*Volume 11 of 12*  
*Final EIR Appendix A – Original Comment Letters*  
***FINAL ENVIRONMENTAL IMPACT REPORT***

***Academy Museum of Motion Pictures Project***

*Case Number: ENV-2013-1531-EIR*  
*State Clearinghouse Number: 2013051086*

## **Appendix A: Original Comment Letters**

WESTSIDE SUBWAY EXTENSION SECTION 1  
GENERAL ARRANGEMENT PLAN  
WILSHIRE/FAIRFAX STATION  
SHEET 10

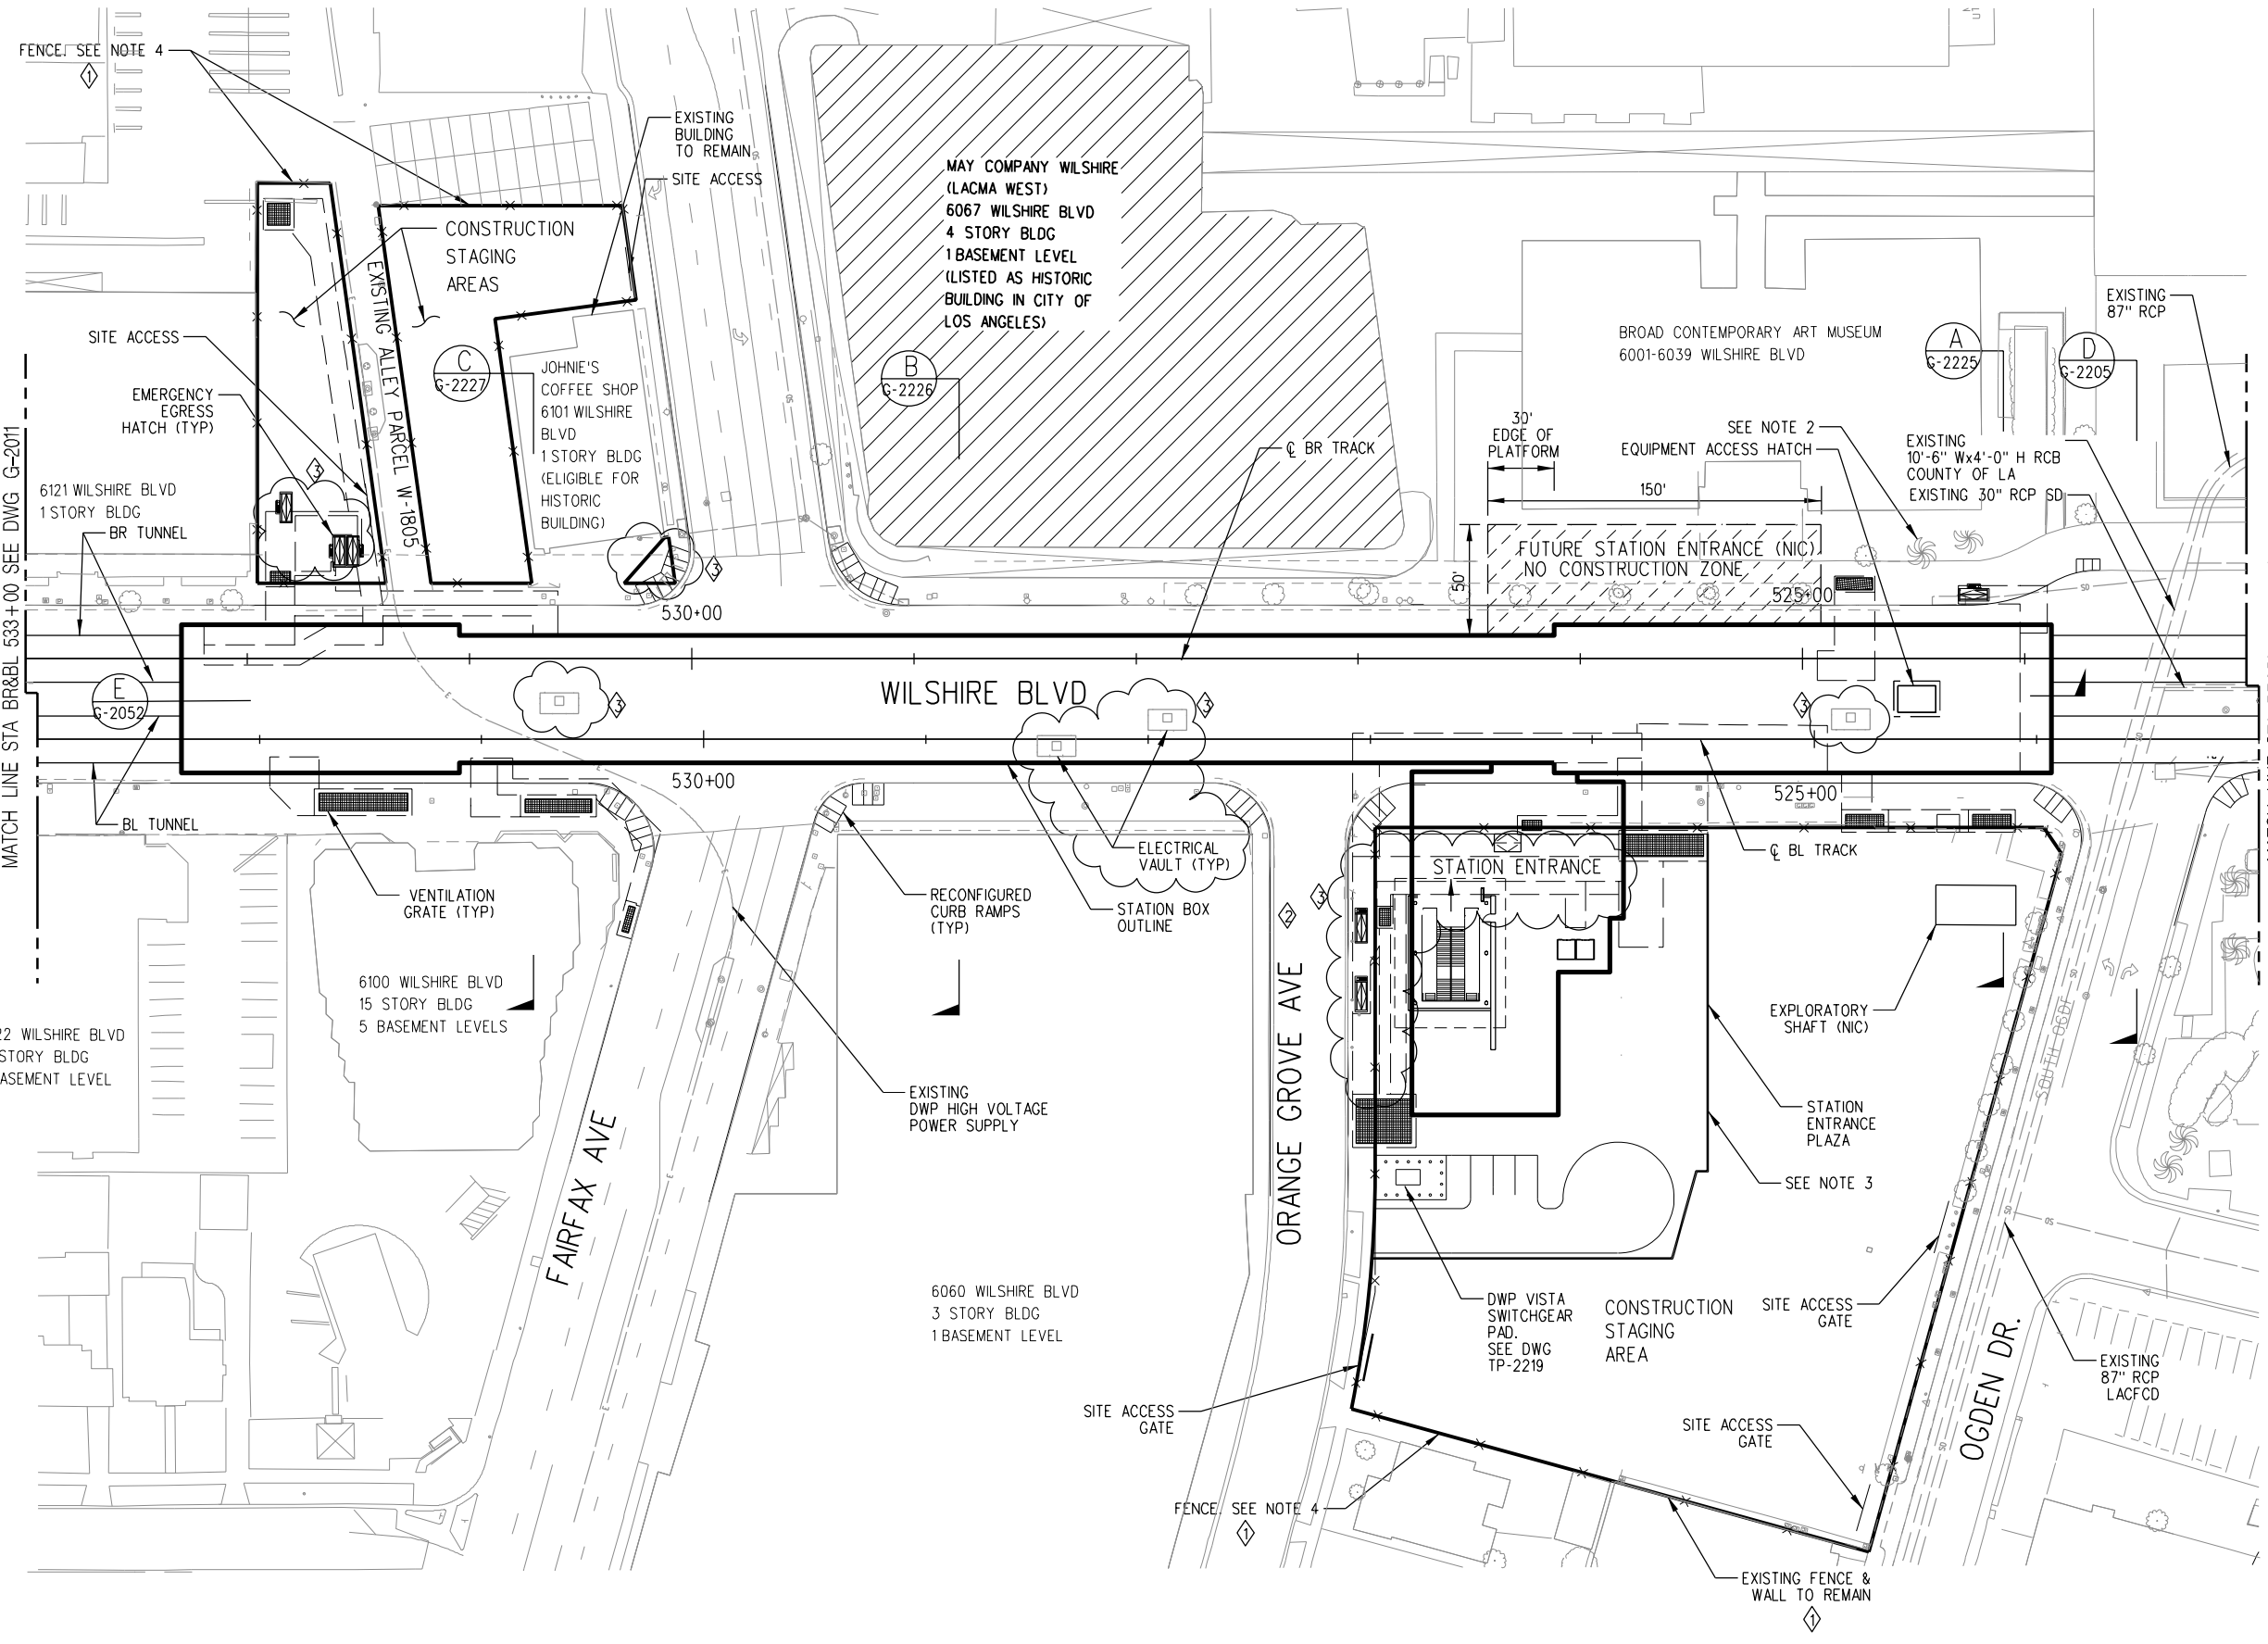
The construction of the Wilshire/Fairfax Station, which is adjacent to the Project, is scheduled to last from 2014 through 2022 with the major activities estimated as follows:

Utility relocation, shoring for the station excavation, street decking, and street restoration will all result in temporary lane closures along Wilshire Boulevard. Street decking, possibly raised in some locations, will be installed curb to curb along the Wilshire Boulevard from Ogden Drive to just west of Fairfax Avenue, and is expected to be in place from about September 2015 through January 2022. During this time, any construction work on the Original Building of the AMMP Project will need to be coordinated with Metro subway construction which could be severely restricted. Subway construction and decking would restrict times and the access for the delivery

of construction materials for the project bordering Wilshire and could restrict or prevent the moving of cranes and equipment needed for the project improvements from Wilshire. Alternative ways to get materials and equipment to the front of the building will need to be evaluated for any construction to the Wilshire side during this period.

4. Page 2-5: In addition to the construction staging area on the south side of Wilshire Boulevard, the Wilshire/Fairfax Station will require some construction staging area on the north side of Wilshire Boulevard, to the west of the Johnie's Coffee Shop property.

19. Page 4.J-44: Please note that the planned construction of the Wilshire/Fairfax Station may disrupt access the existing curb cuts identified for pick-up/drop-off. Access will temporarily be impacted by street level construction of the Wilshire/Fairfax Station during soldier pile installation for most of 2016, street decking in Winter 2017 and during decking removal and street restoration in 2021 and appendage construction in 2022. In addition, potential sections of raised decking along Wilshire Boulevard from 2017 through 2021 may impact the Wilshire Boulevard pick-up/drop-off.

20. Page 4.J-45: During construction of the Wilshire/Fairfax Station, the entrance to the Original Building along Wilshire Boulevard will be accessible along the sidewalk, but direct access from this entrance to the street would most likely be blocked by a construction fence during certain phases of construction. The Original Building will be blocked by fence and k-rail during soldier pile installation for six months in 2016. The AMMP should consult with Metro to coordinate access routes to the Museum during the construction phases of the projects.
